ADDENDUM FOUR
Water Treatment Plant
High Service Pump Upgrades
TDEC Project No.: DW20220948
City of Springfield, Tennessee
Bid No. 1250
Griggs & Maloney Project No. 1141-16

To: All Plan Holders
Owner: City of Springfield, Tennessee
Engineer: Griggs & Maloney, Inc.
Project: Water Treatment Plant
High Service Pump Upgrades
File 1141-16
TDEC Project No.: DW20220948

PROJECT NO. 1141-16
 AUGUST 2022
 DRAWN BY: DSM
 CHECKED BY: ASL
 SCALE: AS SHOWN
 APPROVED BY: BMM
 SHEET NO. C2

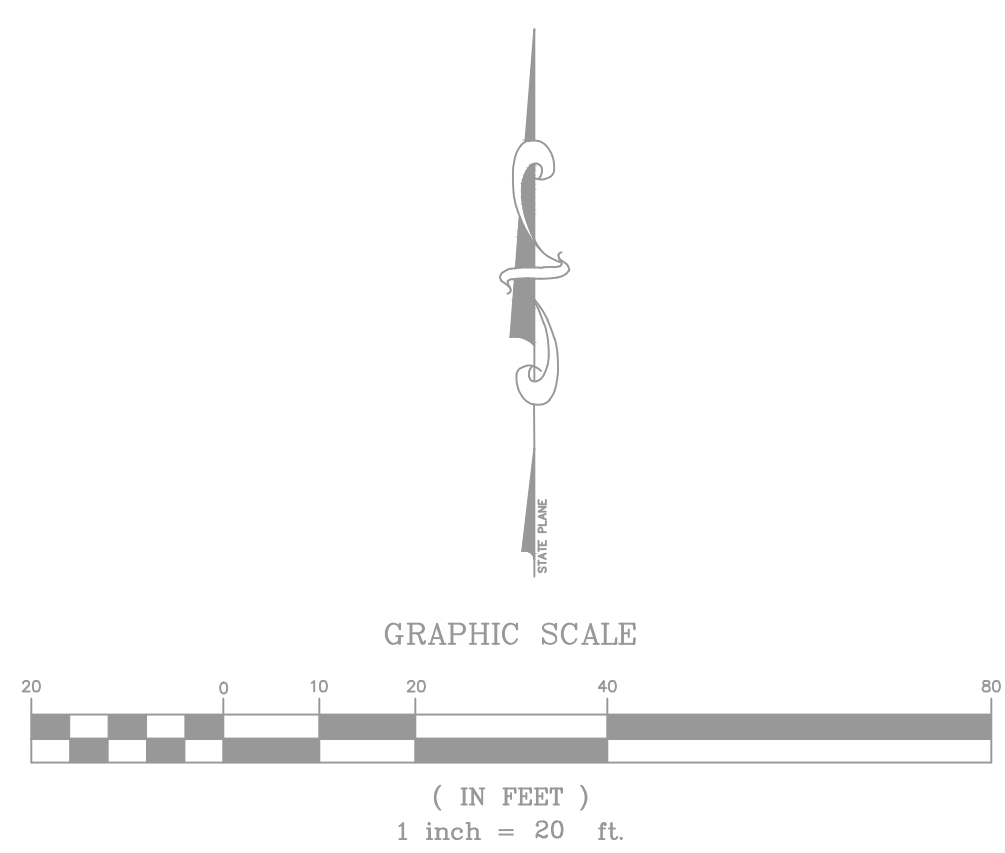
1. **SHEET C2 SITE GRADING PLAN** - Add landing and ramp at North Side doors and eliminate reference to Spoil Stockpile. See re-issued Sheet C2 attached.

PROJECT NO. 1141-16
 DRAWN BY: DSM
 CHECKED BY: ASL
 APPROVED BY: BMM
 SCALE: AS SHOWN
 SHEET NO. C3

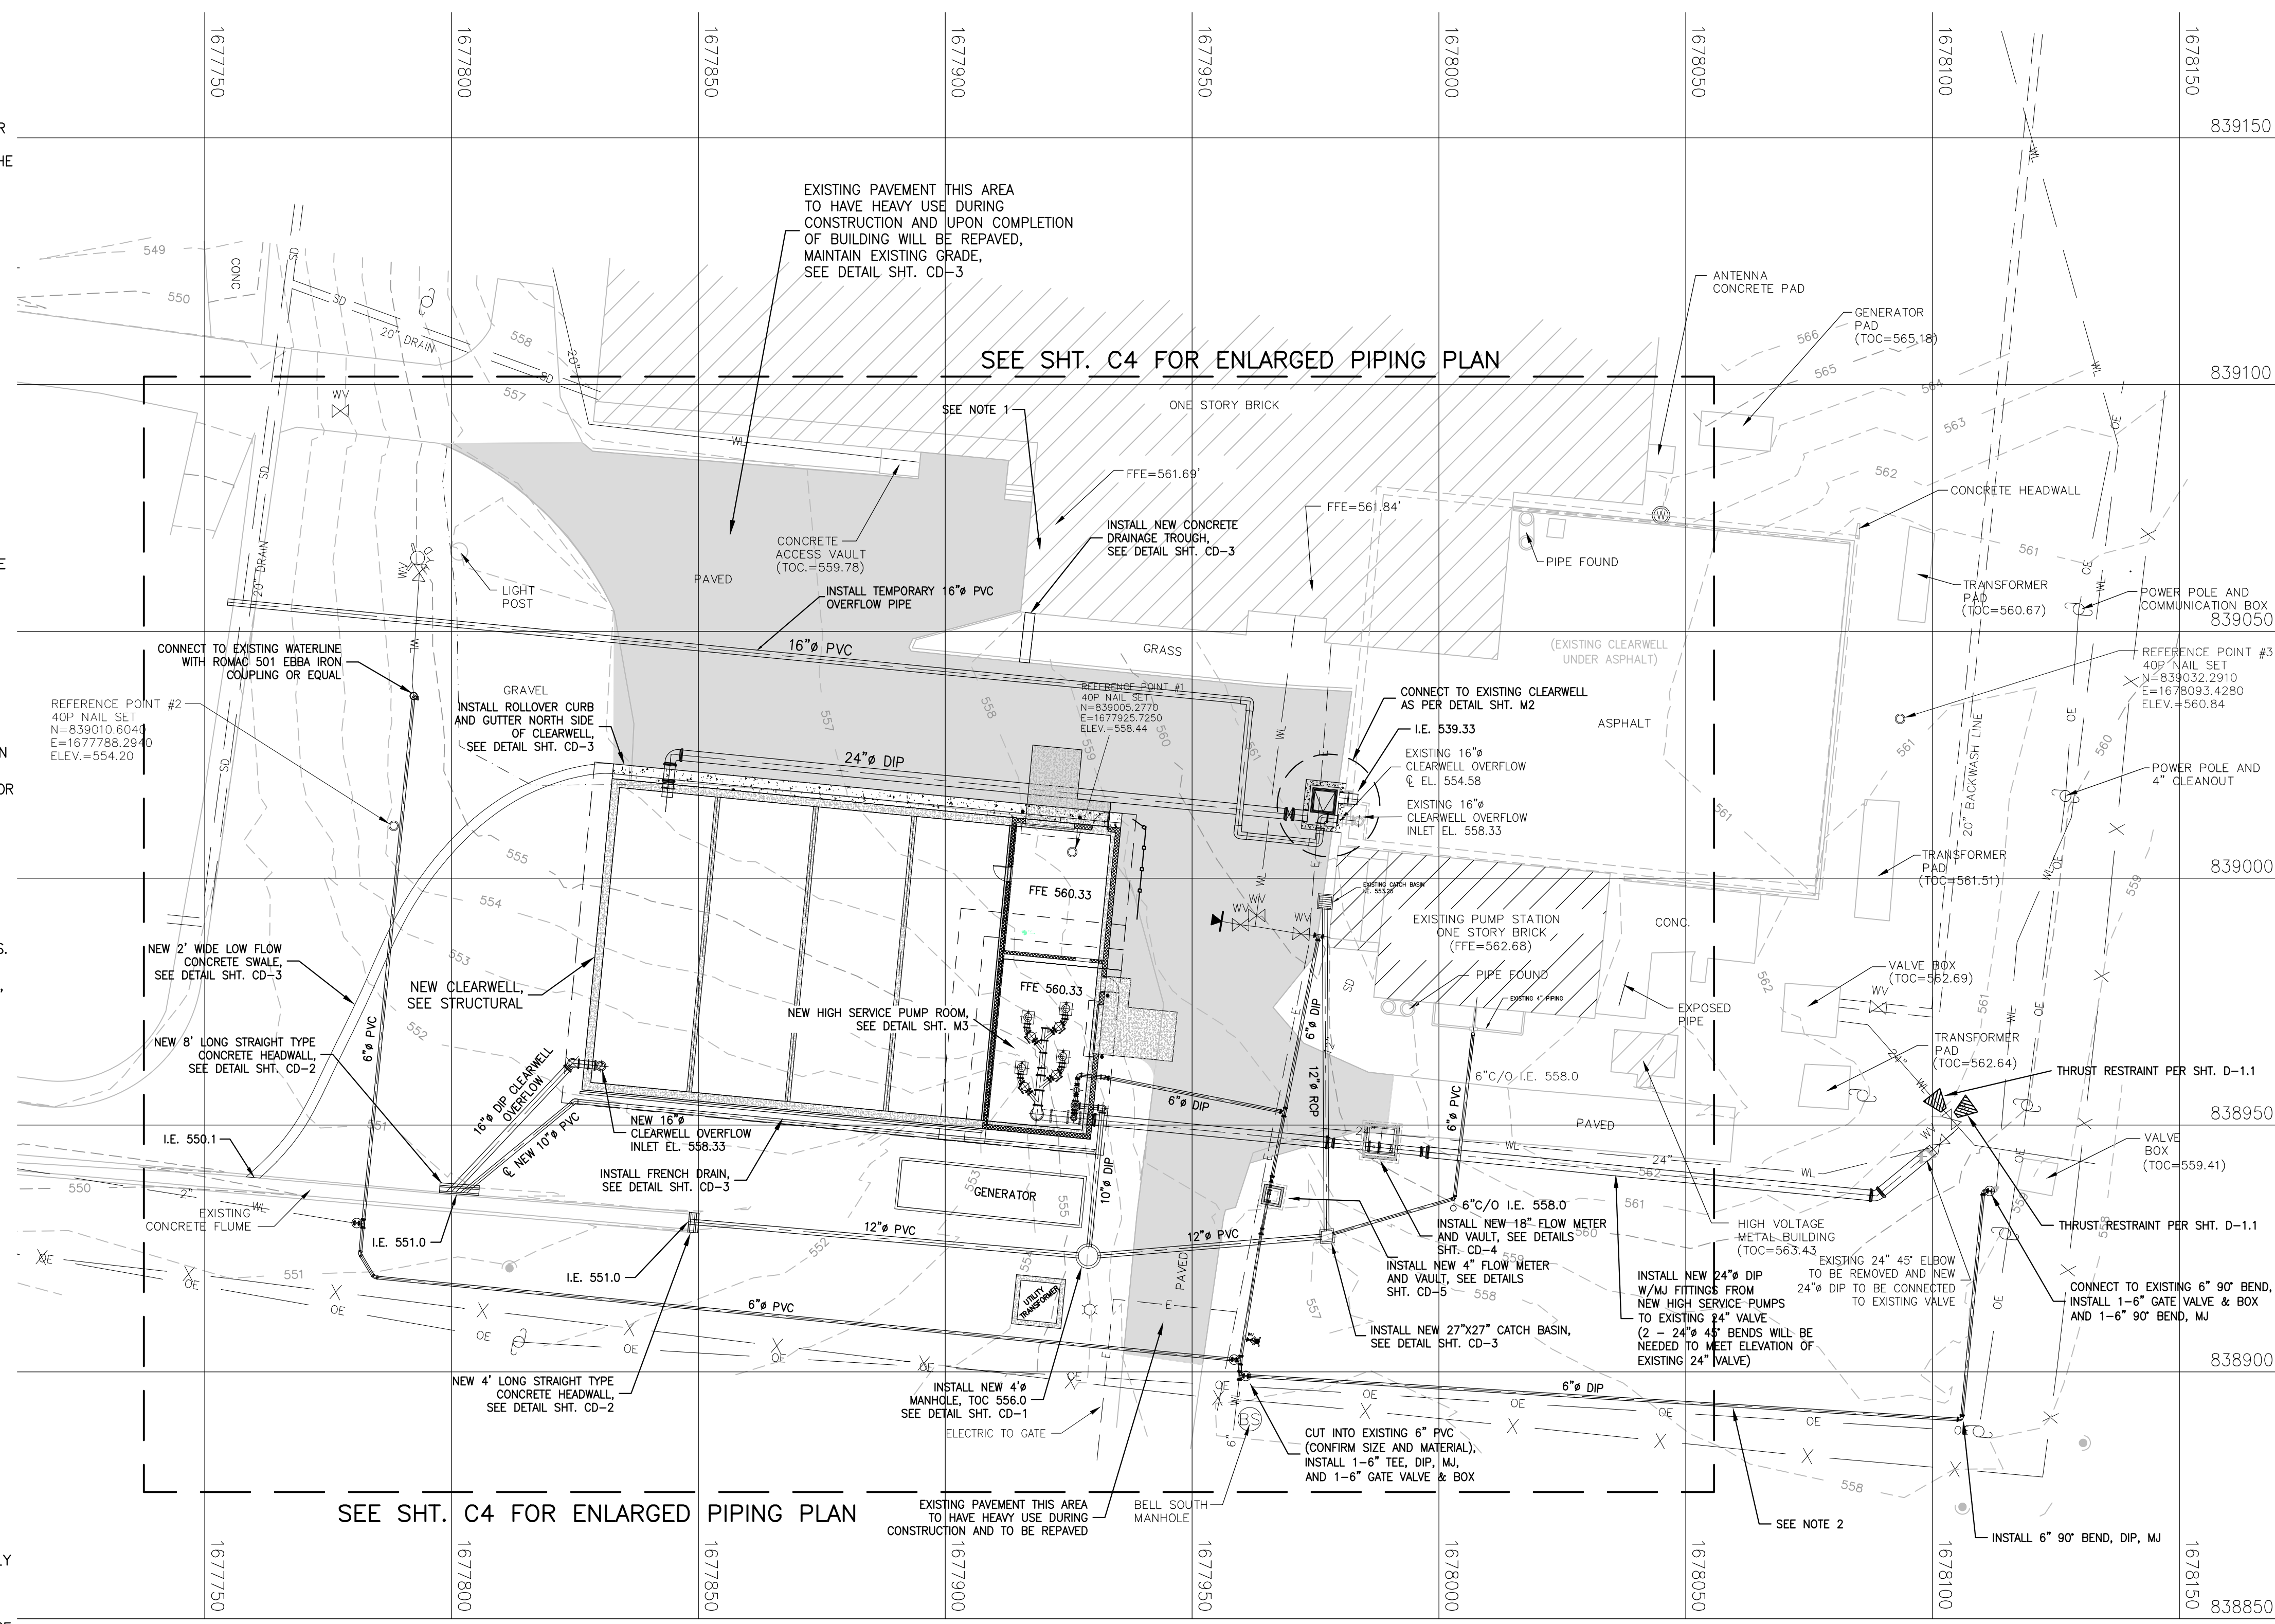
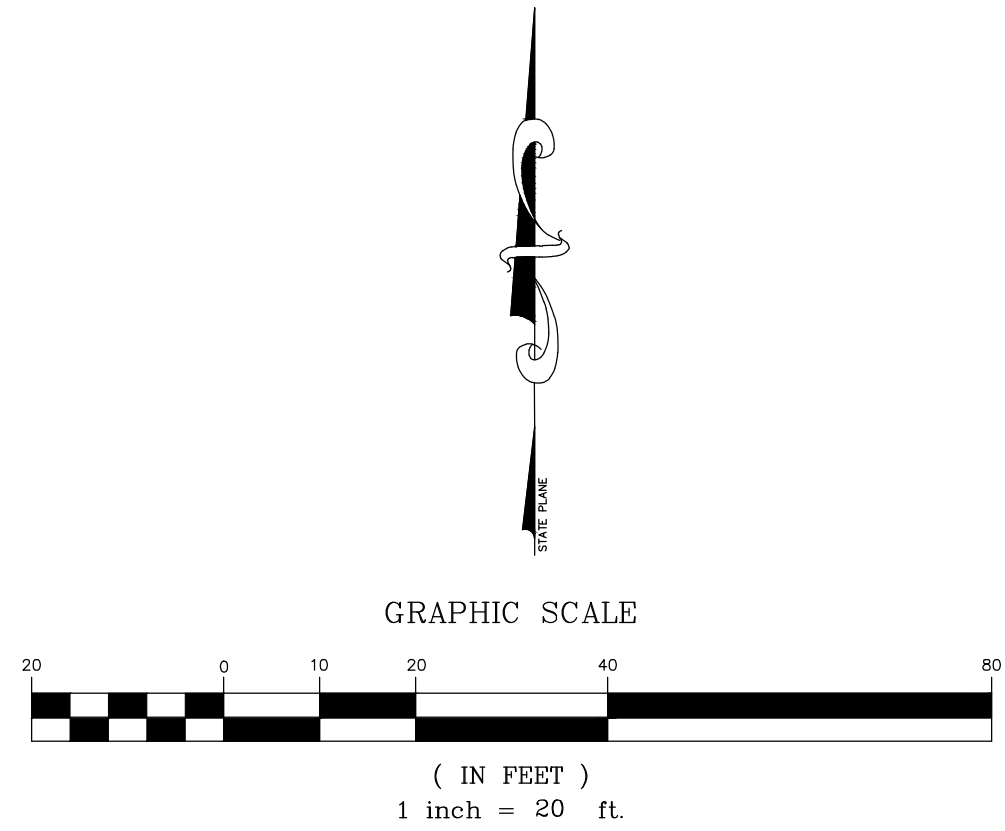
2. **SHEET C3 SITE PIPING PLAN** – Revise Clearwell cleaning notes and piping and add 24” valve. See re-issued Sheet C3 attached.
3. **SHEET C4 ENLARGED PIPING PLAN** – Revise piping and add 24” valve. See re-issued Sheet C4 attached.

LANDING/STAIR

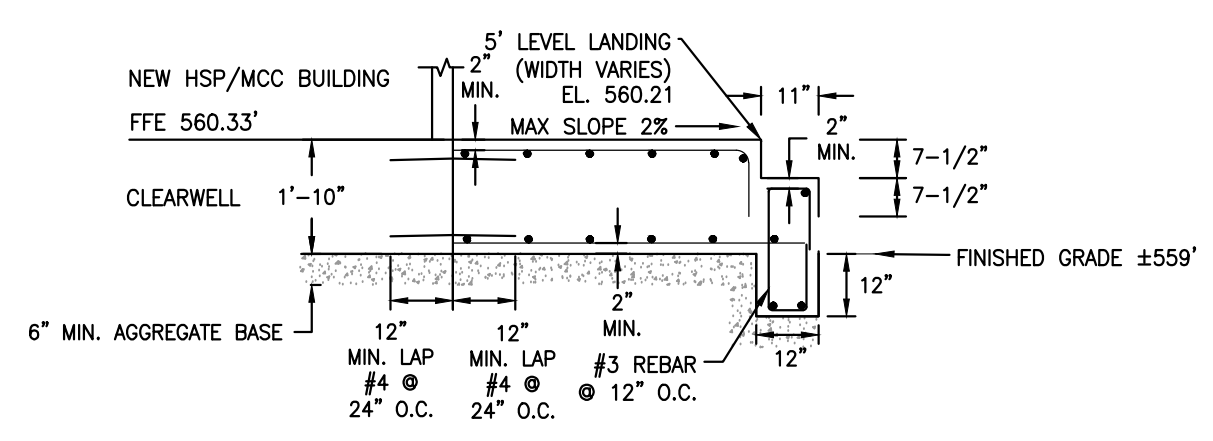
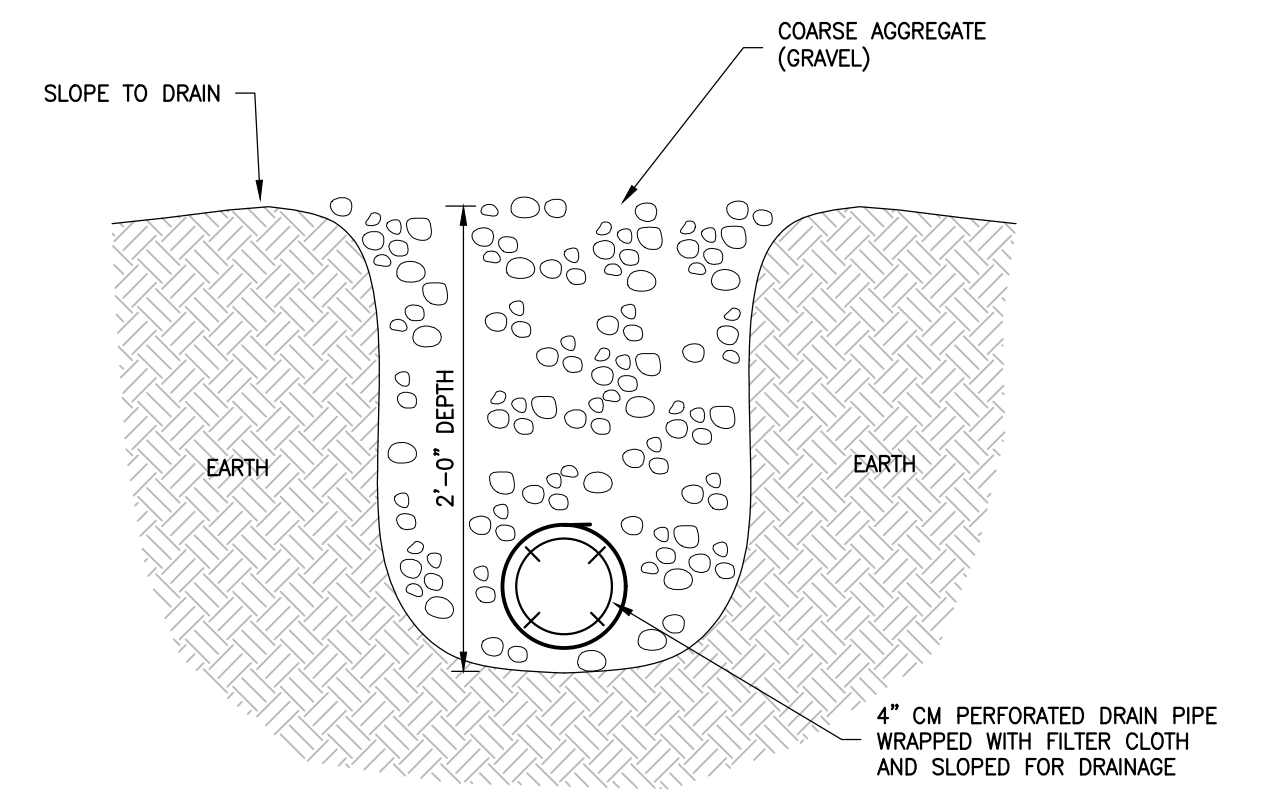
4. **SHEET CD-3 SITE DETAILS** – Added Landing/Stair/Ramp Detail. See re-issued Sheet CD-3 attached.
5. **SHEET D1.0 SITE DEMOLITION PLAN** – Revised 24” pipe removal and abandon limits. See re-issued Sheet D1.0 attached.
